City of Surrey
PLANNING & DEVELOPMENT REPORT

File: 7911-0327-00

Planning Report Date: June 25, 2012

in order to permit the development of two business park buildings

PROJECT: MORGAN GATEWAY BUSINESS PARK
 3122 CROYDON AVE, SURREY, B.C.
 DRAWING TITLE: LANDSCAPE PLAN
 DATE: 12/11/12 DRAWING NUMBER: L1
 SCALE: 1/8" = 1'-0"
 DRAWN BY: [Name]
 CHECKED BY: [Name]
 OF 5
 12-029

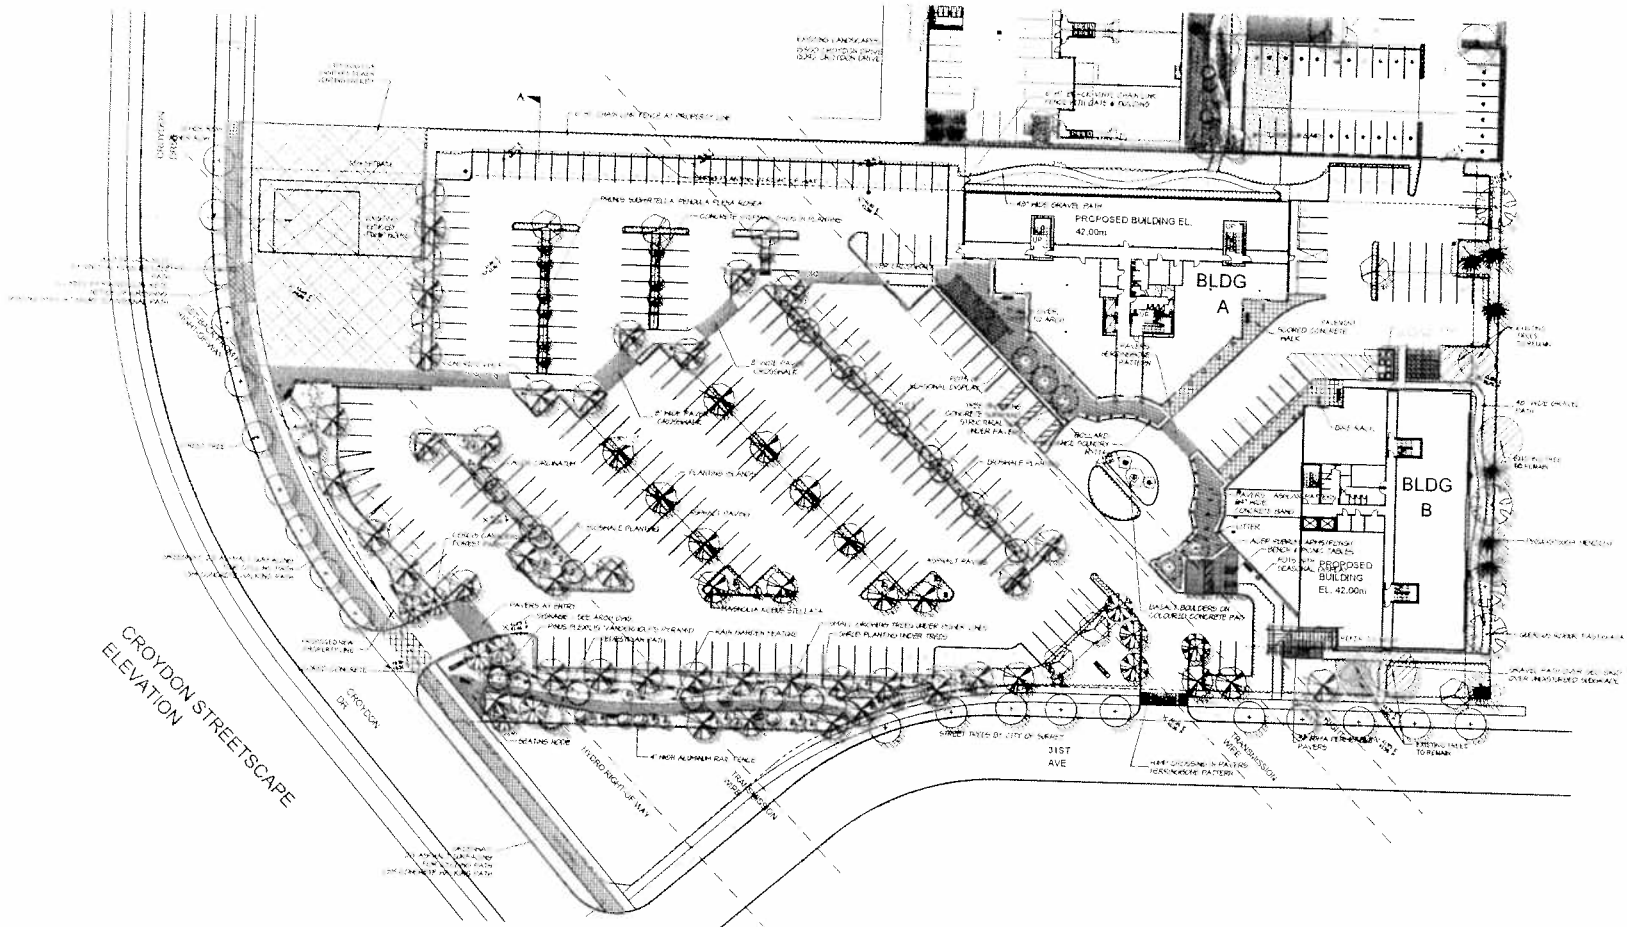
- Regarding the upper terrace, some trees were added to provide shade, however *Syringa vulgaris* are very broad spreading and are not going to provide much shade, especially in their location in the planter (during mid-day working hours / lunch when it will be needed).

- Consider a better (broader) shade tree (e.g., *Gleditsia tricanthos* var *enermis*) and adding planters in the patio area (e.g., 4'x4' precast) so that chairs / tables could be moved around and underneath, as required. I think it will help to make the space more comfortable in the warmer summer months.

- At the parking entrance off Croydon there is a bike path crossing which should have some special treatment. These are high conflict zones. However, I see it is beyond the property line so it may not be part of the developer's responsibility? If the site servicing agreement allows, the pavers indicating the entrance could be moved to the bike crossing.

- There are two bioswales, one that includes *Acer circinatum*, however the second bioswale does not include it. Is there a reason for this?
